Work Change Directive Proposal
Truman Waterfront Park Phase 1A
 ITB 15-022
 P.O. #

Location: Truman Waterfront Park, Key West
Scope: Misc Scope Adjustments (FCD 003)

To:	Andi Fraley, AIA, LEED AP Senior Project Manager	Date:	April 11, 2016
Organization:	Charley Toppino & Sons		
Project Name:	Truman Waterfront Park		
RE:	Summary of Delta 3 Drawing Revisions		
BA Project No:	14041		
From:	Kirk J. Olney, RLA Senior Landscape Architect 305-860-3709		
CC:	File Randy Hollingworth – Bermello Ajamil & Partners Inc. Jim Bouquet – City of Key West Director of Engineering Terry Justice – City of Key West Construction Coordinator Gary Volenec – City of Key West City Engineer Allen Perez – Perez Engineering & Development Brandon O'Flynn – Perez Engineering & Development

FIELD CHANGE DIRECTIVE
No. 03

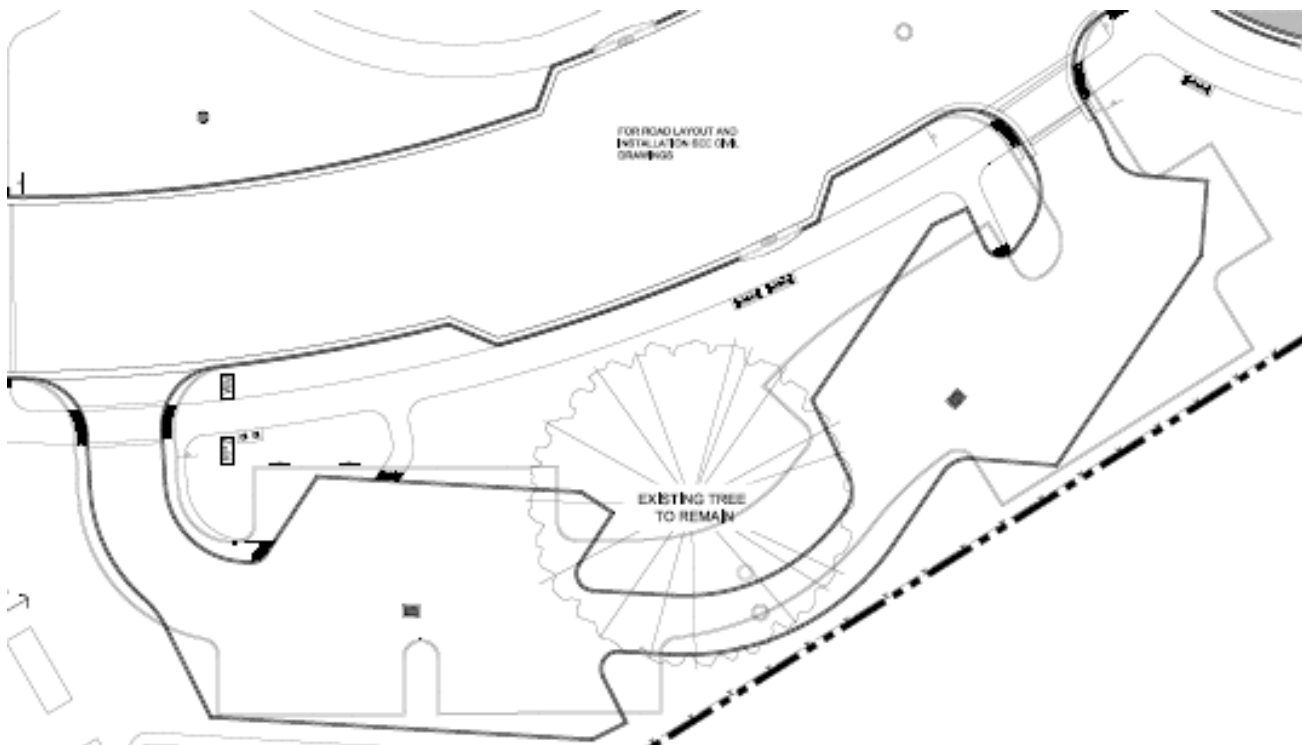
The Delta 3 drawing revisions generally consist of reconfiguring the parking near the existing Seagrape tree (described as Tree No. 38 on LT-05 and LT-06) along the east side of the property from square spaces with two-way traffic (the lighter edge of pavement below) to angled spaces with one-way traffic (the darker edge of pavement lines below). The diagram below shows the general shift of the road alignment from the bidding documents, shown in light gray lines to the current design, shown with black lines:
